Reference: License No. SNM-42, Docket 70-27

Subject: Request to Amend License SNM-42, Chapter 5, *Nuclear Criticality Safety*

## **Summary of Changes to Chapter 5 of the SNM-42 License Application**

**Figure 1: An Example of Addition of Margin in a Region of Positive Bias**

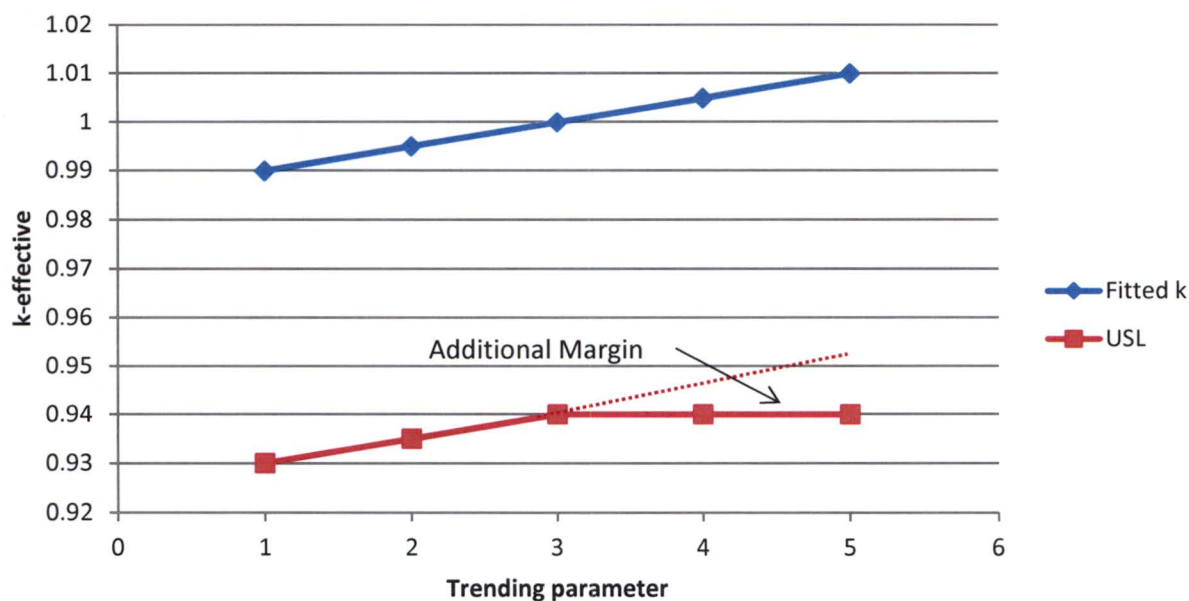
Changed the wording on a positive bias to say when the trended  $k_{eff}$  value exceed unity, additional margin will be used to compensate for the positive region.

This is consistent with ANSI/ANS-8.24 and does not create a condition that invalidates the statistical method by altering the data or fitted equations. Instead additional margin is added in the region that the fit is greater than unity which adjusts the USL to compensate. A simplified example is shown below:

**Figure 2: Mixture <sup>235</sup>U, <sup>239</sup>Pu and <sup>241</sup>Pu with Water, Water Reflected**

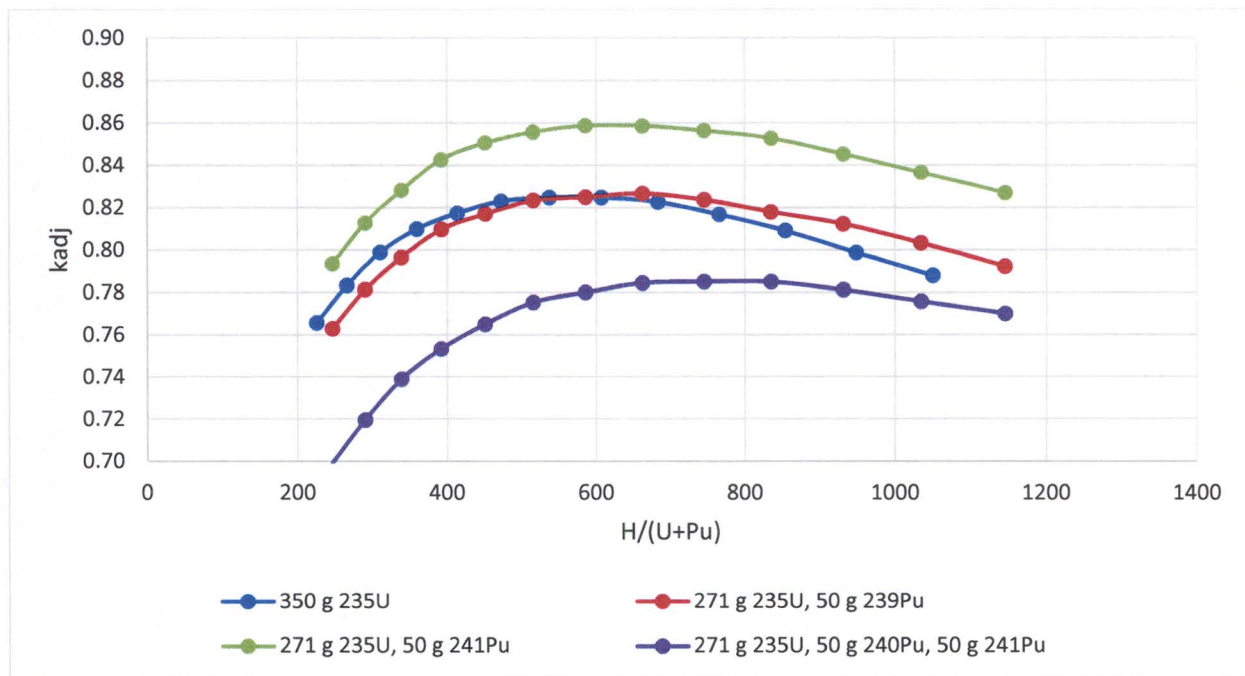
The table (histogram) of the mass limits to Pu wt% is replaced by an equation that is more commonly used. The equation is the sum of fractions of fissile uranium mass over 350 grams and the plutonium mass over 220 grams.

Calculational studies on the mixture of uranium metal and plutonium metal mixed with water in a sphere and water reflected were performed to attain an understanding of the relationship to the mixtures and  $k_{\text{eff}}$ . The current validation does not include plutonium, but for the sake of this study, the bias for HEU will be applied to plutonium and mixtures of uranium and plutonium.

The uranium density was set at 18.81 g/cm<sup>3</sup> and the plutonium density was set at 19.85 g/cm<sup>3</sup>. The uranium was assumed to be 100 percent enriched in <sup>235</sup>U. The principal fissile forms of plutonium (<sup>239</sup>Pu and <sup>241</sup>Pu) were investigated. The radius of the sphere was increased to increase the H/(U+Pu) until the optimum was established.

<sup>241</sup>Pu is more reactive than <sup>239</sup>Pu. The unrealistic aspect of this is if <sup>241</sup>Pu is present, there will be <sup>240</sup>Pu which is essentially a thermal absorber. Since <sup>241</sup>Pu is produced from neutron capture in <sup>240</sup>Pu and since <sup>241</sup>Pu is fissile and has a shorter half-life than <sup>240</sup>Pu, there will be more <sup>240</sup>Pu than <sup>241</sup>Pu. The last curve in the figure included 50 gram of <sup>240</sup>Pu in addition to the 50 grams <sup>241</sup>Pu. With <sup>240</sup>Pu present, the system is less reactive than if just <sup>235</sup>U or <sup>235</sup>U and <sup>239</sup>Pu are present.

With the limits on the amount of unencapsulated plutonium and the <sup>233</sup>U, the fraction critical equation provides an adequate method of handling mixed species.

$$\frac{{}^{233}\text{U}(g) + {}^{235}\text{U}(g)}{350} + \frac{{}^{239}\text{Pu}(g) + {}^{241}\text{Pu}(g)}{220} \leq 1$$
